# **TITLE 21 REWRITE**

**Review of Planning and Zoning Commission Recommended  
Amendments to the Provisionally Adopted Title 21**

## **Chapter 7 - Part II**

**Date:** September 27, 2012  
**To:** Assembly Title 21 Committee  
**From:**  Jerry T. Weaver, Jr., Director  
**Subject:** Review of Proposed Amendments to Provisionally Adopted Chapter 7 – Part II

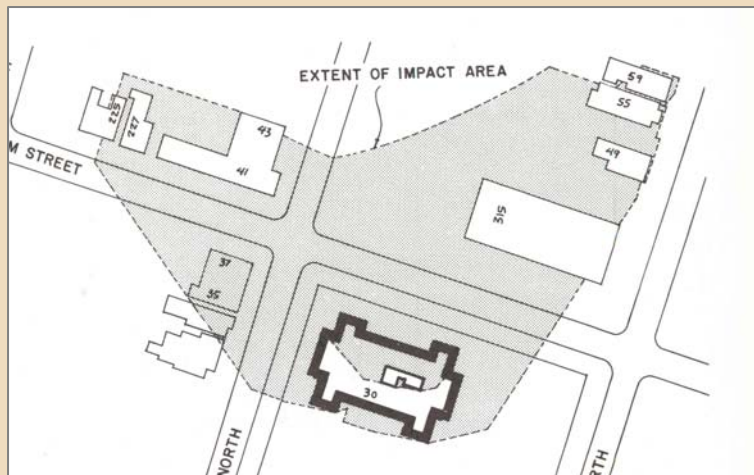
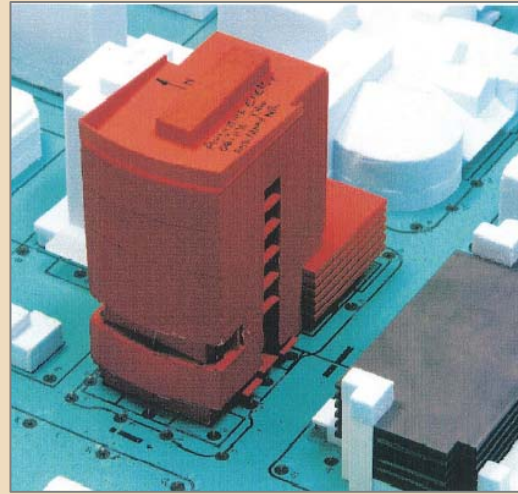
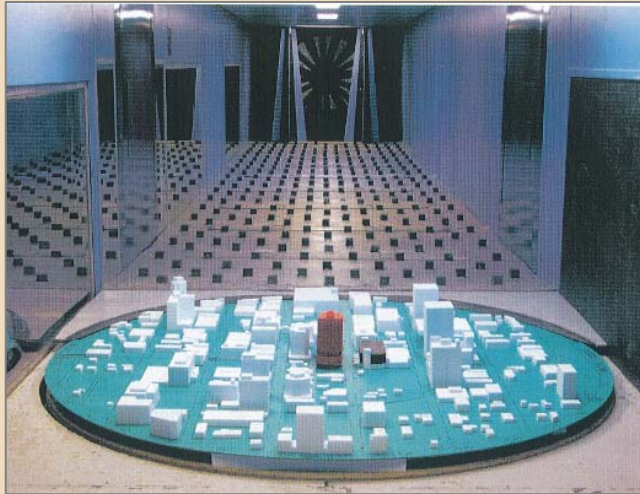
- The Department has revised the draft shadow impact study provisions to be simpler and more flexible. The sunlight access criteria have been revised such that a tall building can be constructed if it minimizes or mitigates its shadowing impacts through its placement on the site, orientation, and/or building massing techniques such as step-backs or slender floor plates.

**Building Placement or Step-backs in Form**

**Sloping Roofs**

A shadow impact study determined that this proposed building would shadow residential buildings and a greenhouse to the north. Through its site plan review process, the city’s planning commission negotiated adjustments to the shape of the building and its placement on the lot to reduce these impacts.

**Slender Towers**

**Example Wind Study: Augustine Energy Center (2008)**

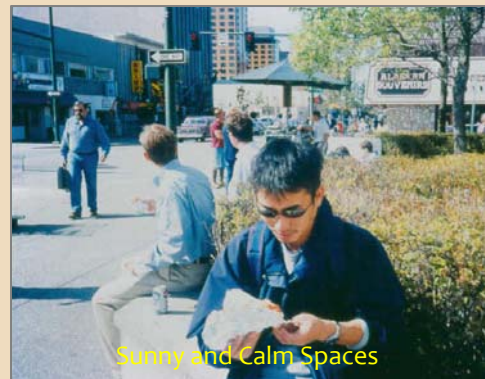
An initial screening-level wind assessment by RWDI determined that a wind tunnel test would be advisable to predict wind effects around the proposed high rise Augustine Energy Center in downtown Anchorage. The wind tunnel test was conducted with a scale model of Downtown. The wind study helped the design team adjust the building shape so that wind speeds in surrounding public streets and sidewalks would remain within comfort and safety criteria. (RWDI; Neeser Construction)
